APPEAL SUMMARY

Appeal ID: 18952 Project Address: 3330 SE 69th Ave Hearing Date: 2/6/19 Appellant Name: Tim Ayersman Case No.: B-006 **Appellant Phone: 971-200-7213** Appeal Type: Building Plans Examiner/Inspector: John Cooley Project Type: commercial Stories: 3 Occupancy: E, B, A-2, A-3 Construction Type: II-B **Building/Business Name:** Fire Sprinklers: Yes - fully sprinklered throughout Appeal Involves: Erection of a new structure LUR or Permit Application No.: 18-169865-LU Plan Submitted Option: pdf [File 1] Proposed use: Middle School (Grades 6-8)

APPEAL INFORMATION SHEET

A-502

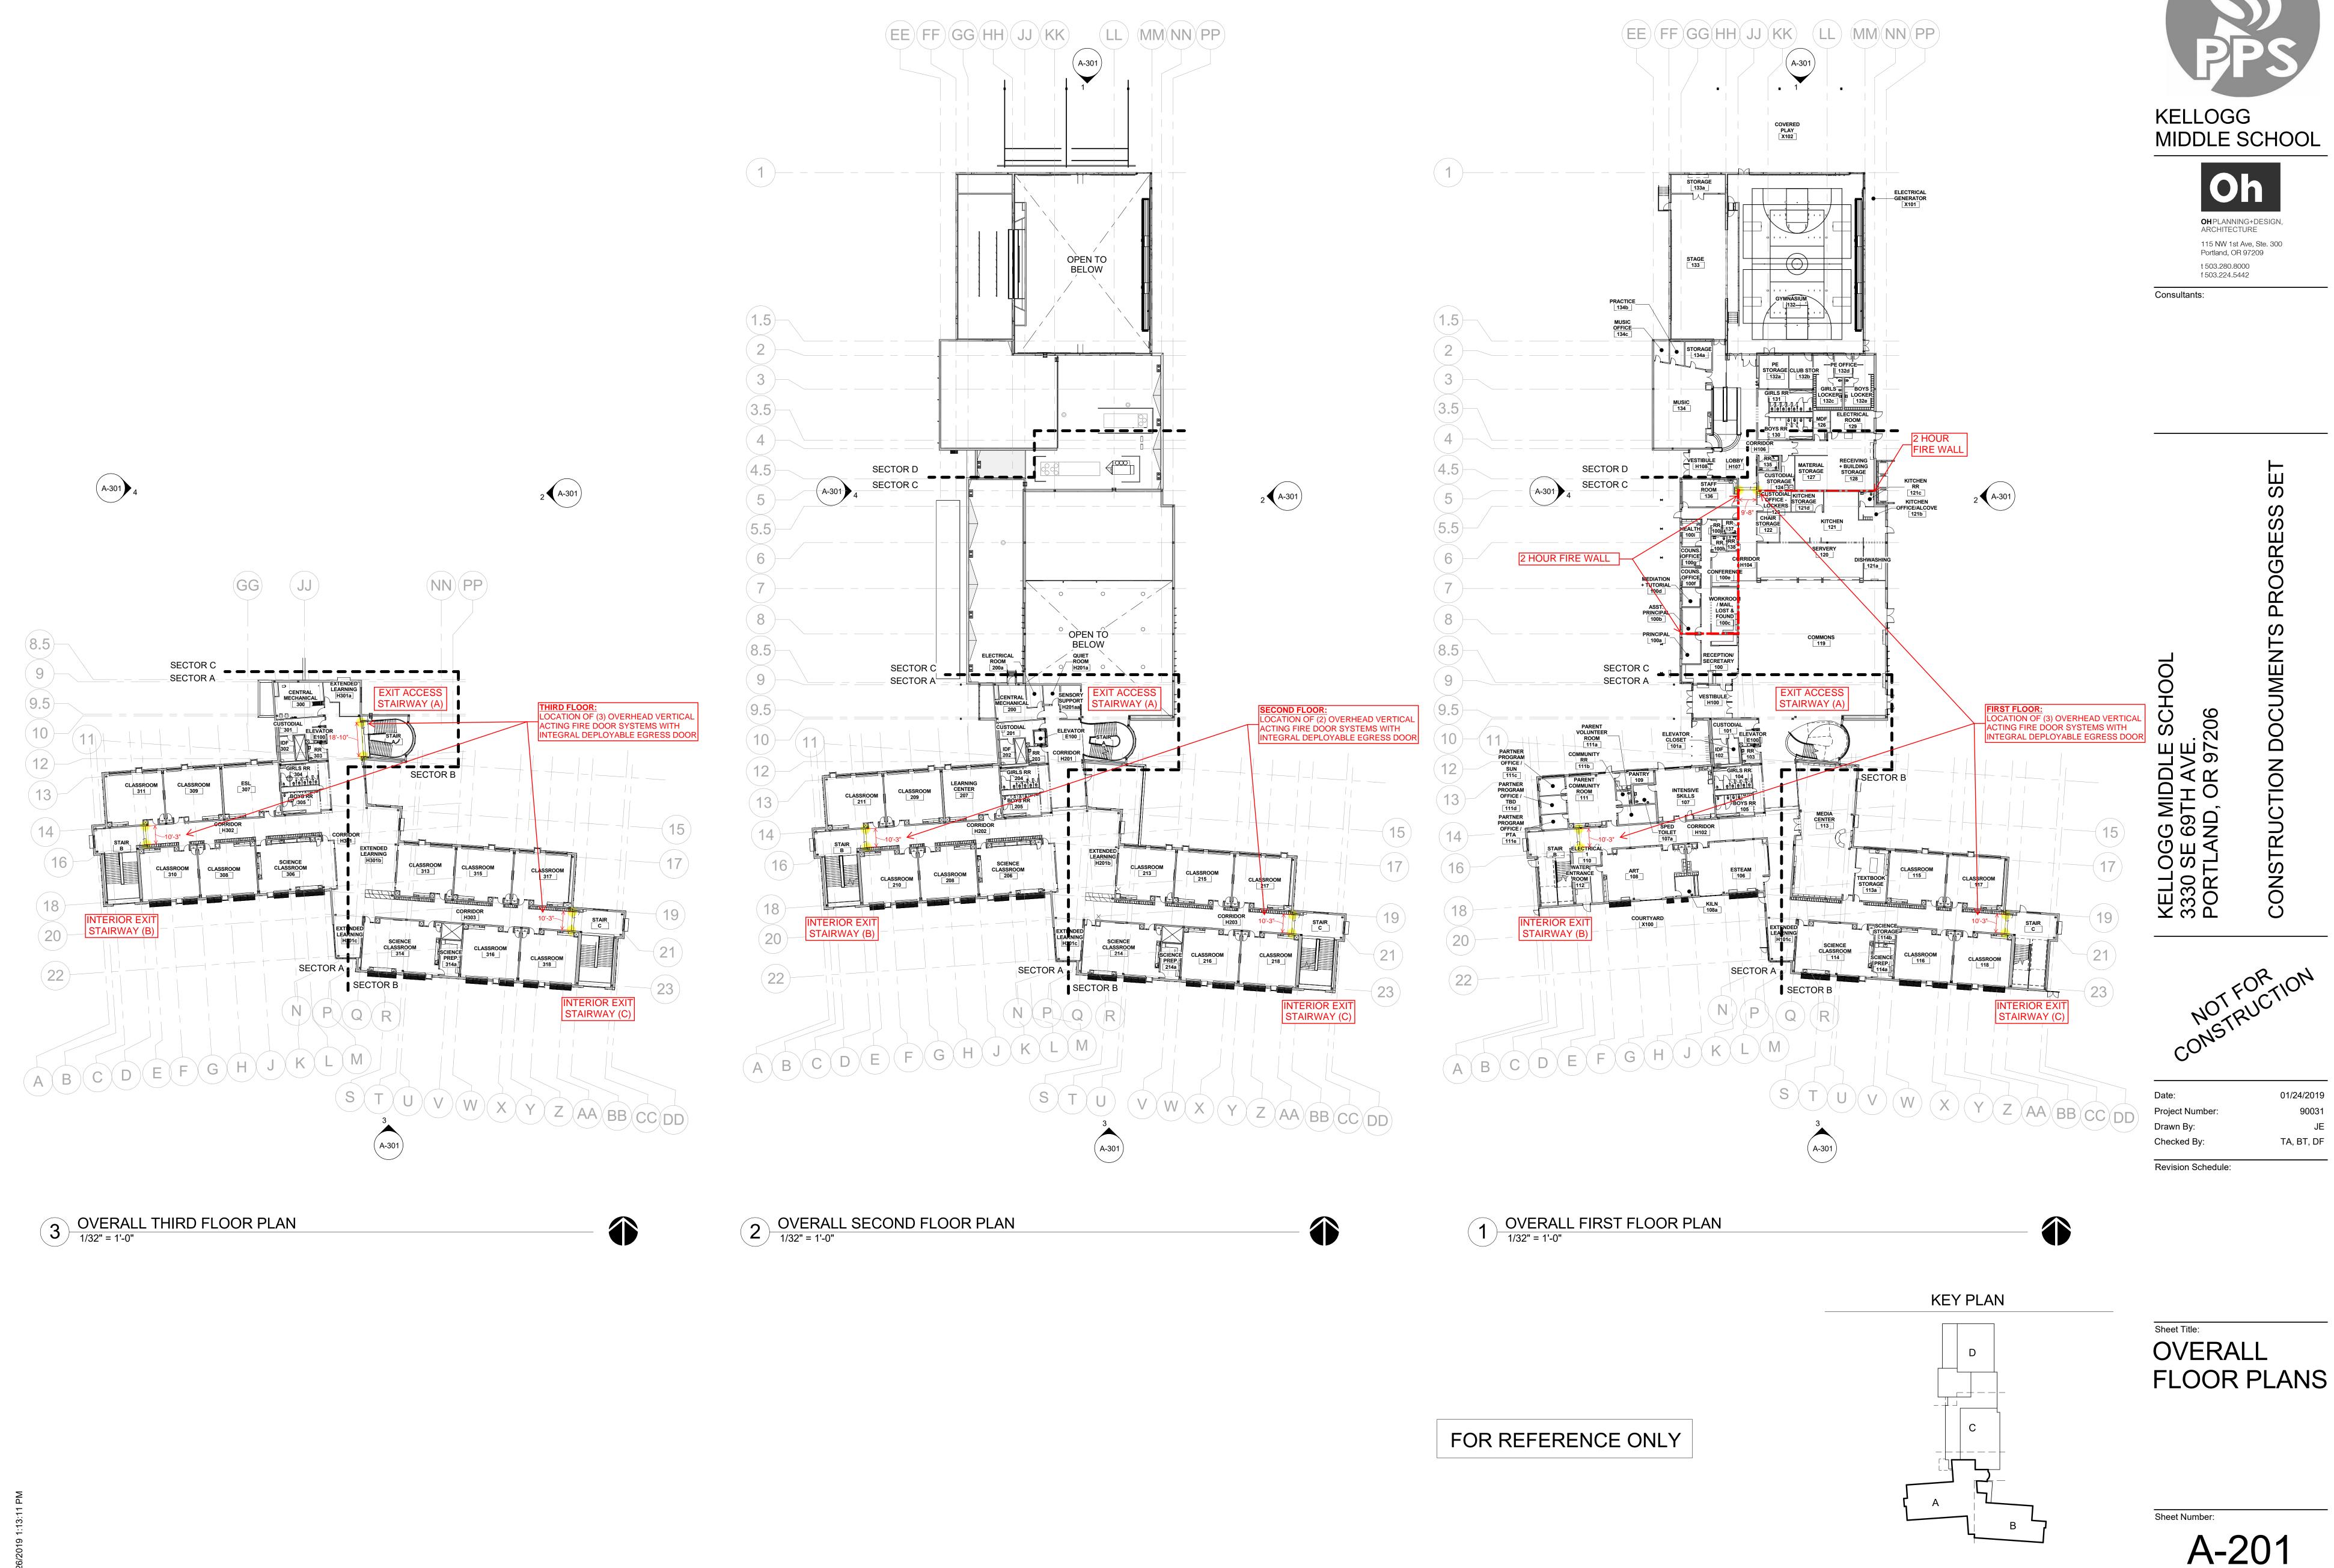
At the school's exit access stairway, floor one and floor two atmospherically communicate between floors. At the third floor, an overhead vertical acting fire door system with an integral deployable egress door separates the occupied third floor to create one volume between the second and third floor. The proposed design meets the regulation's requirements to atmospherically communicate between only two stores as intended for life safety and fire protection by separating the occupied third floor from the lower two floors.

SEE ATTACHED STAIR SECTION (A-502) AND FLOOR PLANS (A-201) FOR LOCATION OF THE EXIT ACCESS STAIRWAY (A).

- 1. Use of roll down fire doors to provide atmospheric separation from adjacent stories: Granted as proposed.
- 2. Use of roll down fire doors as part of an exit stair enclosure. Granted as proposed.
